NRC Technical Basis for CASS aging management

MRP 2015-025 vs. BWRVIP-100

Slide 2

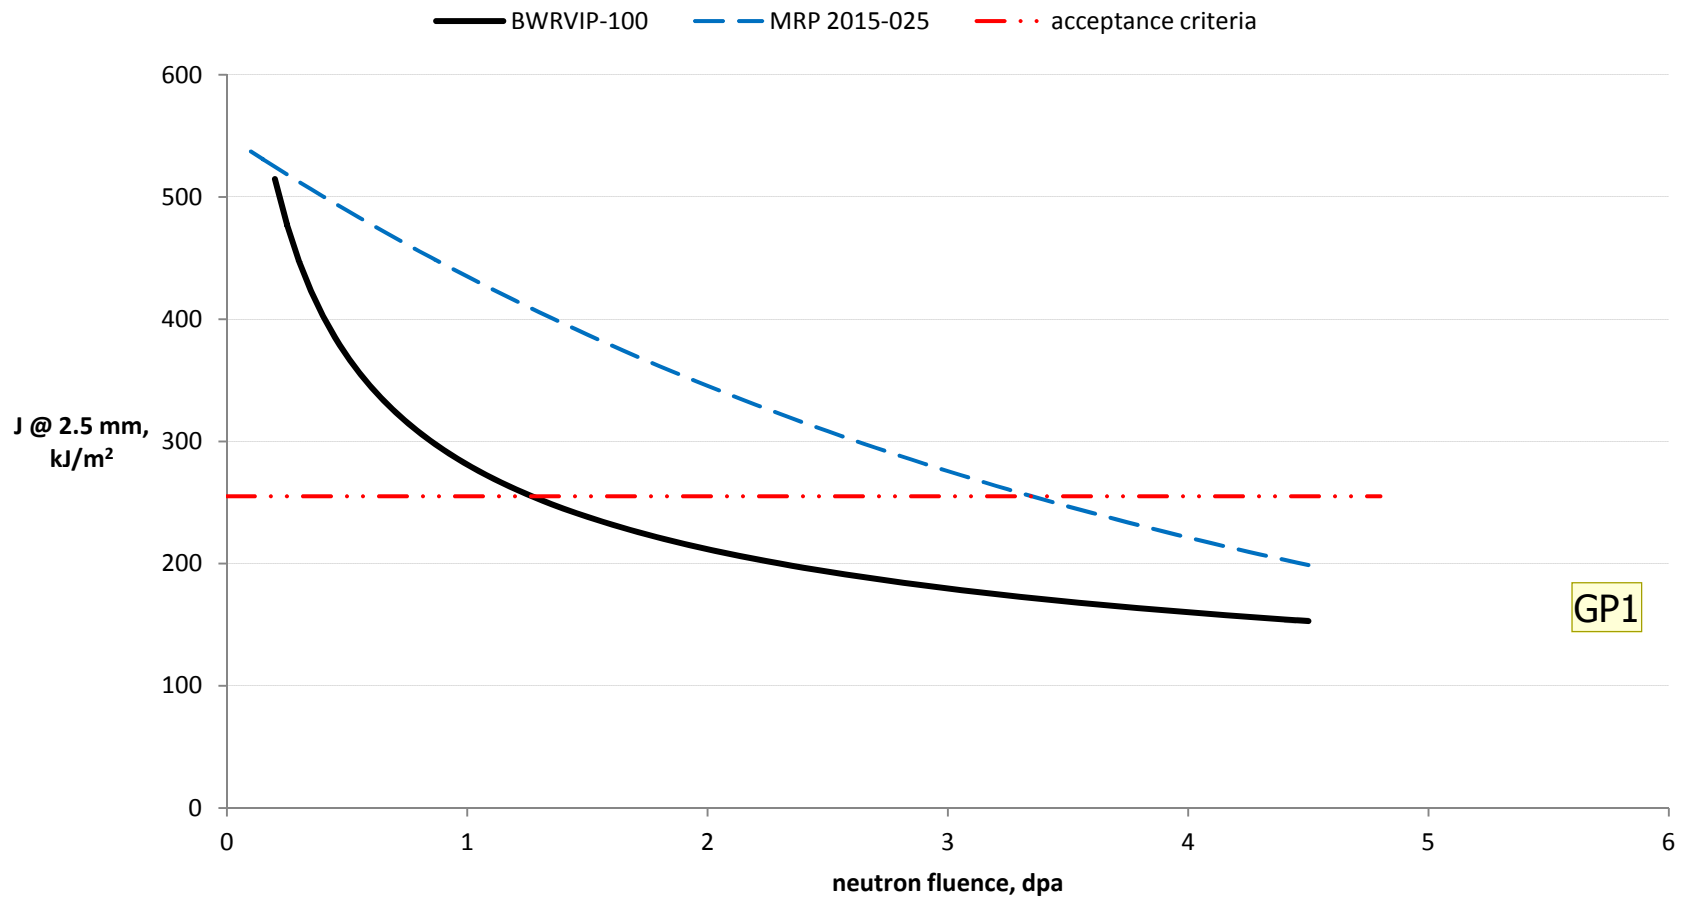
isn't this correct for our position?

Slide 4

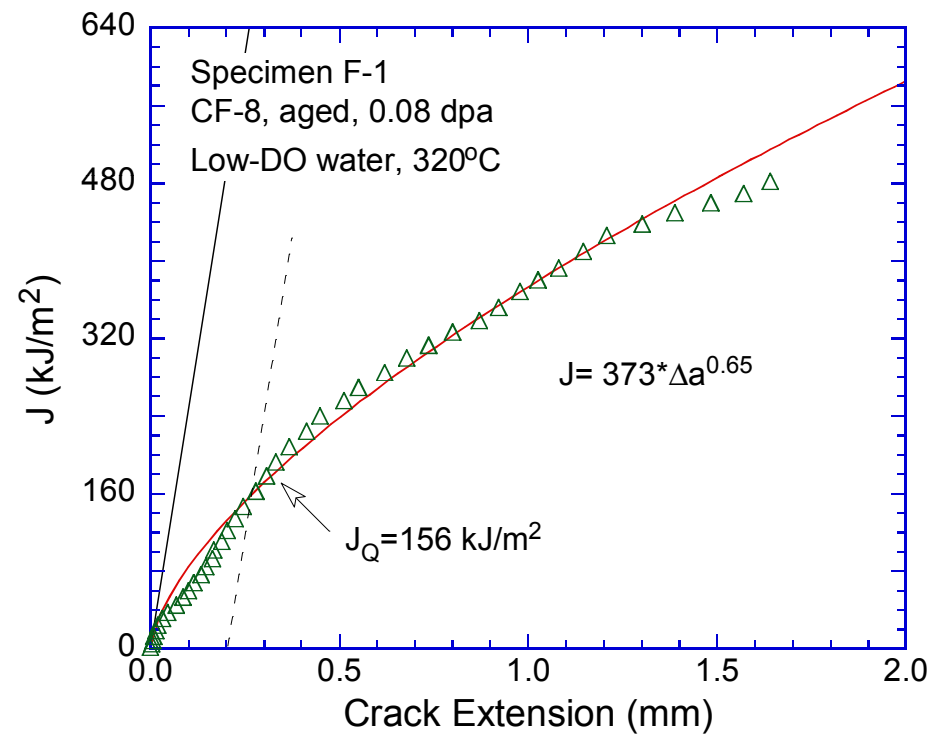
should be "loss of fracture toughness" instead of embrittlement
